Notice of Intent

Type of Action: APD Change

Offline Production Cementing

Variance Request for Offline Production Cementing

Process and Equipment

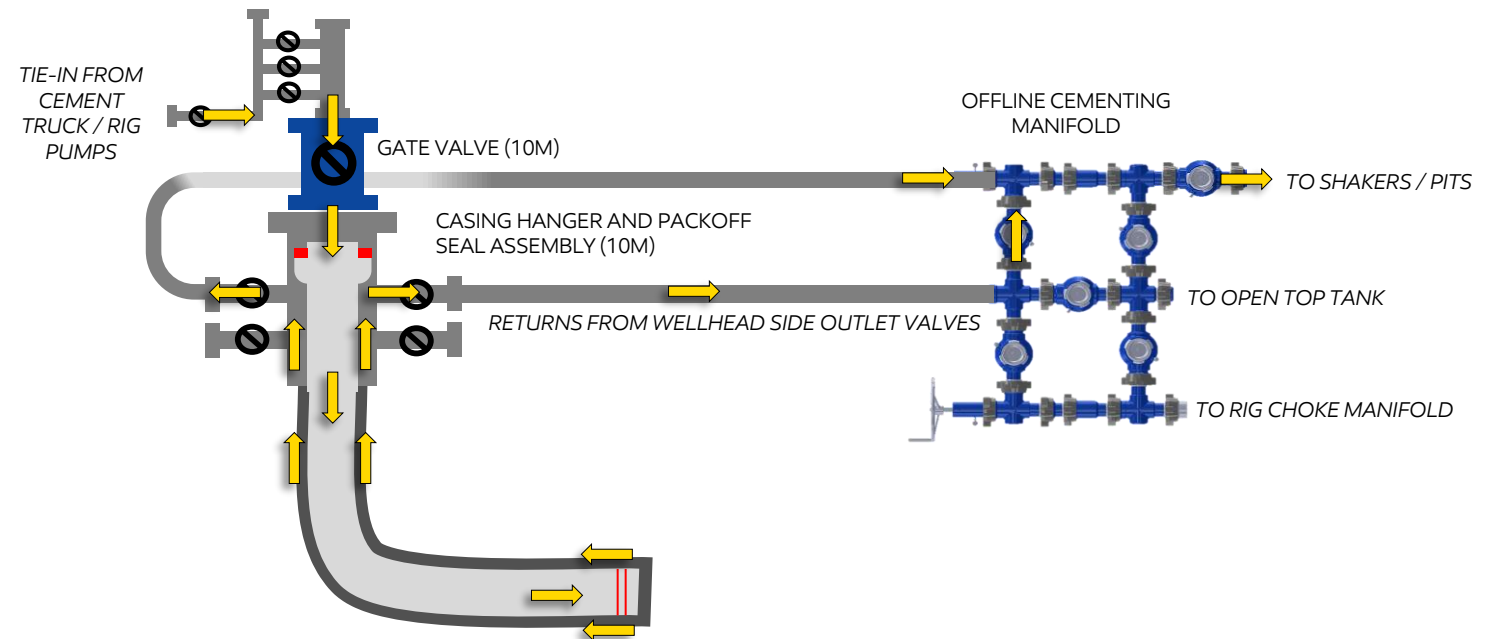
1. Rig BOP replaced by gate valve and WH adaptor assembly (10M rated)
2. Addition of offline cementing manifold and high pressure iron to direct fluid returns to rig active system and/or choke manifold
3. Packoff annulus barrier in place and tested prior to cementing operations (10M rated)
4. Cement truck performs cement job displacement (vs rig pumps)
